The drawings have been changed from the present application to comply with the Examiner's objections on page 2 of the Office Action. The Preliminary Amendment provides that every feature of the invention is shown in the drawings and a description of how Figure 4 relates to Figure 8 has been added as per the drawing objection found at subparagraph 1 of paragraph 1 on page 2 of the Office Action. Please note that subparagraph 2 of the drawing objections has been corrected in the present application by cross hatching Figure 4A. Also, subparagraph 3 of the drawing objections has been corrected in the present application by drawing the angle theta (θ) as between the longitudinal centerline axis of the trace and a side of the pad, as is described on page 7, lines 16-20 of the specification.

The Examiner had objected to Claims 16-26 of the parent application. These claims exist in the continuation application as Claims 1-11. The existing Claims 1-11 in the continuation application have now been cancelled and replaced with new Claims 12-36.

Fig 1B

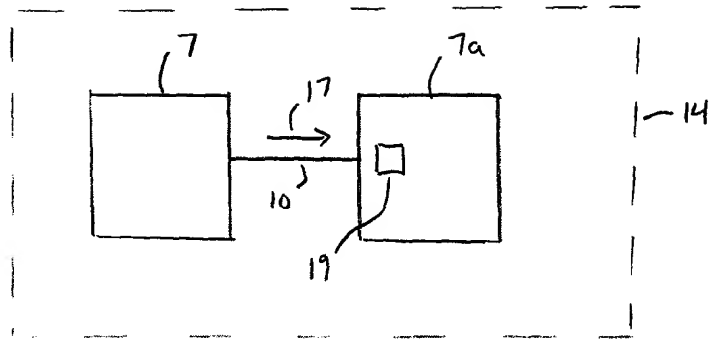
Figure 1B has been added. It shows a block diagram of two components, 7 and 7a, connected on a printed circuit board 14. The components are connected via a trace 10 as is described on page 1, lines 13-15. Digital signals 17 travel from component 7 to component 7a on printed circuit board 14 as is described on page 2, lines 2-4. The destination component 7a has an input receiver 19 which is triggered by the digital signal 17 as is described on page 2, line 4.

Fig 1C

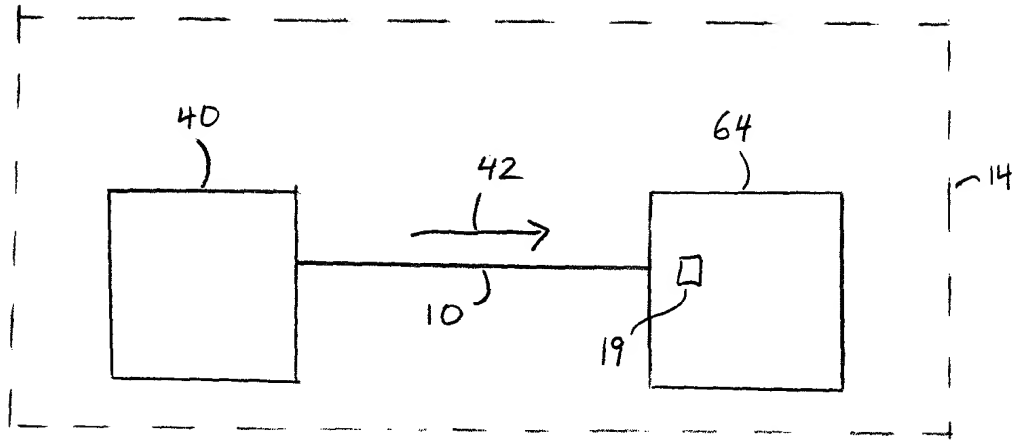
Figure 1C has been added. It shows a block diagram of a memory controller and memory as an example of two components connected on a printed circuit board. On page 2, lines 5-7, the memory controller and the memory are described as an example of the description on page 2, lines 1-5. Therefore, the diagram of Figure 1C is almost identical to that of Figure 1B, the diagram depicting the description of page 2, lines 1-5. Figure 1C has component 7 replaced by memory controller 40, digital signal 17 replaced by control signal 42, and component 7a replaced by memory 64. This is in accordance with the specific example described on page 2, lines 5-7.
